Addendum #1

Project Name: T-Bone Spillway

Bid Number: F24-09-079

Date: September 23, 2024

EXHIBIT 1

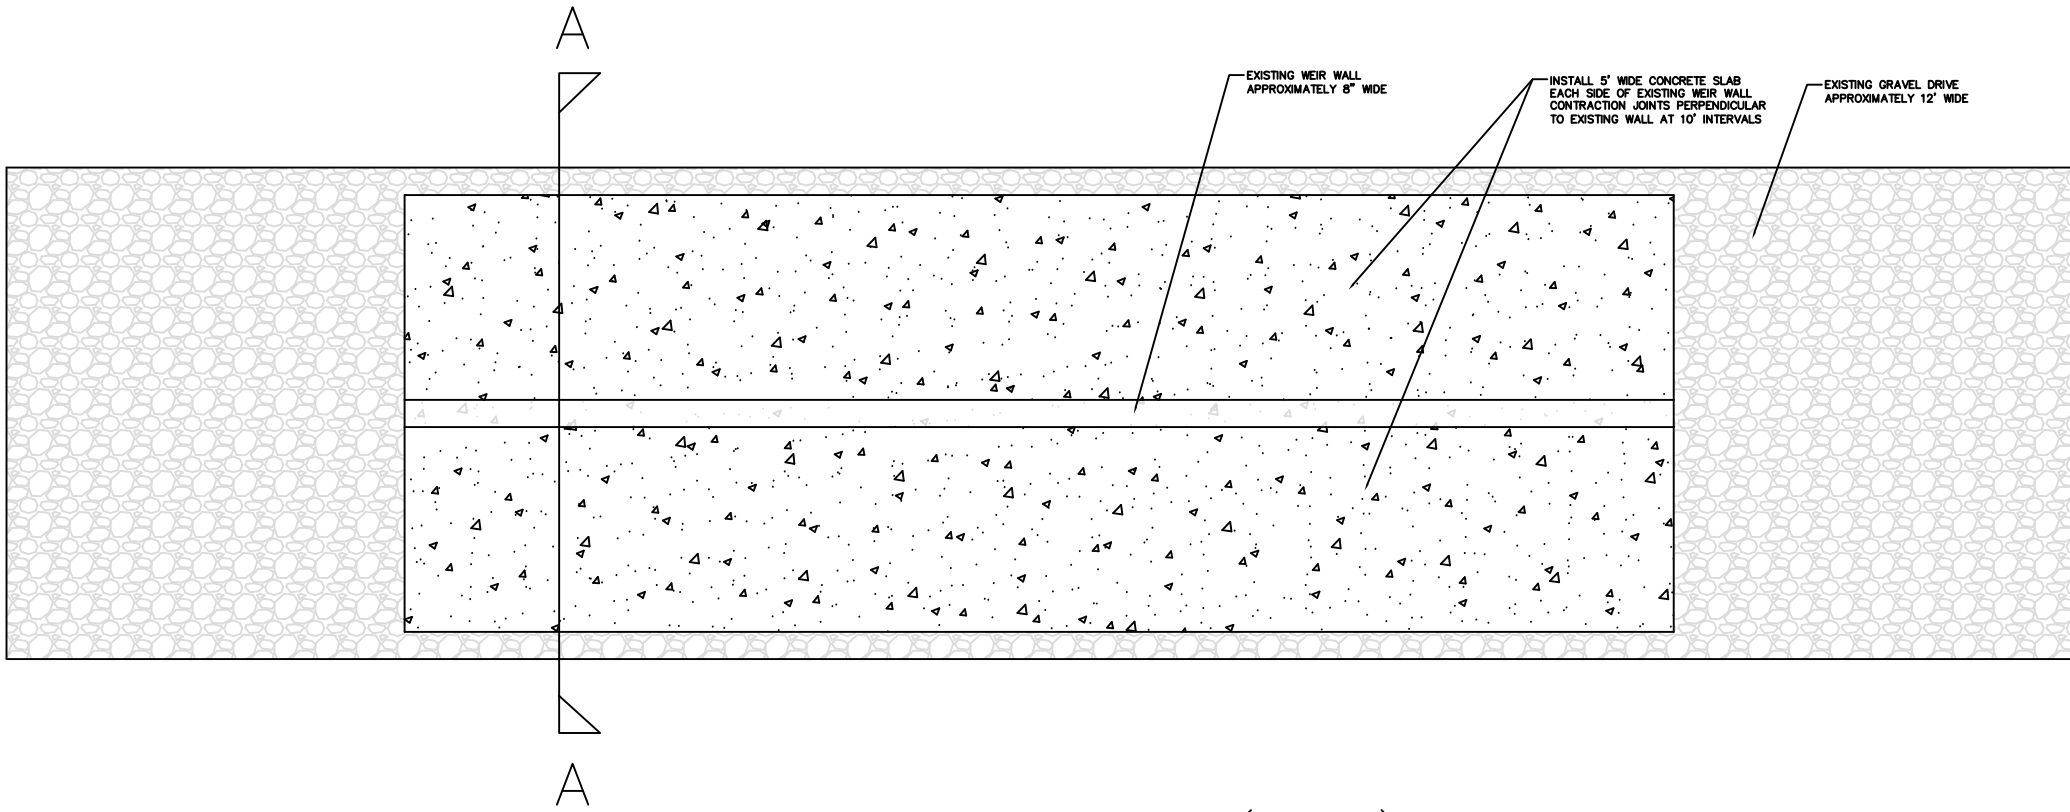
Question #1 Please confirm the contract is adding 8' to each side of the existing weir? Are we lengthening or widening that area?

The project is to add a 5' wide concrete slab along each side of the existing weir wall. This will create a drivable surface, approximately 10' – 8" wide along the length of the weir wall, which is approximately 166' long. See Exhibits 1-3 attached.
